Access Compliance Report

Public Rights-of-Way

(Curb Ramps)

Intersection ID: 21535	Main Street: WOODSTOCK_DR	Cross Street: WOODSTREAM_DR	Location: W
ADA ID: AD216D7B2221	Ramp Type: PerpDiag	Initial Pass/Fail: Fail	Overall Compliance: No
			Severity Score: 13.75

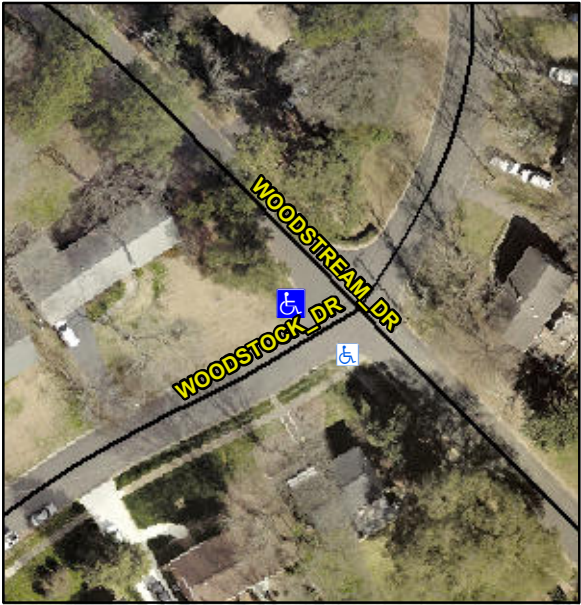
Codes/Mitigation Info/Possible Solution			Field Measurements/Component Compliance		
	Possible Solutions:		Compliance	Description	Data
	Remove & Replace Curb Ramp With Two New Directional Ramps or Equivalent.		N/A	Ramp Length (in)	49.0
			Yes	Ramp Width (in)	48.0
			N/A	Flare Type LT	N/A
			N/A	Flare Slope LT (%)	N/A
			N/A	Flare Traversable LT?	N/A
			N/A	Landing Length (in)	N/A
			N/A	Landing Width (in)	N/A
			N/A	Landing Slope (%)	N/A
			N/A	Landing X Slope (%)	N/A
<p>Surveyor Notes:</p> <p>N/A</p> <p>PROW/ADA:</p> <p>Not Found, R304.2.2, R304.5.3</p>			N/A	Flare Type RT	N/A
			N/A	Flare Slope RT (%)	N/A
			N/A	Flare Traversable RT?	N/A
			N/A	DWS Provided?	N/A
			N/A	DWS Contrast?	N/A
			N/A	DWS Length (in)	N/A
			N/A	DWS Full Width?	N/A
			N/A	DWS Offset (in)	N/A
			N/A	Gutter Ponding?	N/A
			N/A	Gutter Lip Ht (in)	N/A
			N/A	Painted X Walk1?	No
				X Walk 1 Direction	To NE
			N/A	X Walk 1 Width (in)	N/A
				X Walk 1 Slope (%)	2.1

X Walk 1 X Slope (%)	0.1
			N/A	Ramp inside XWalk1?	N/A
				Road Slope (%)	0.4
				Road X Slope (%)	0.2
			N/A	Any Obstructions?	N/A
				Obstruction Type	
Total Cost:		\$ 3200.00			
			N/A		N/A
			Yes	Surface Condition? (G/P)	Good
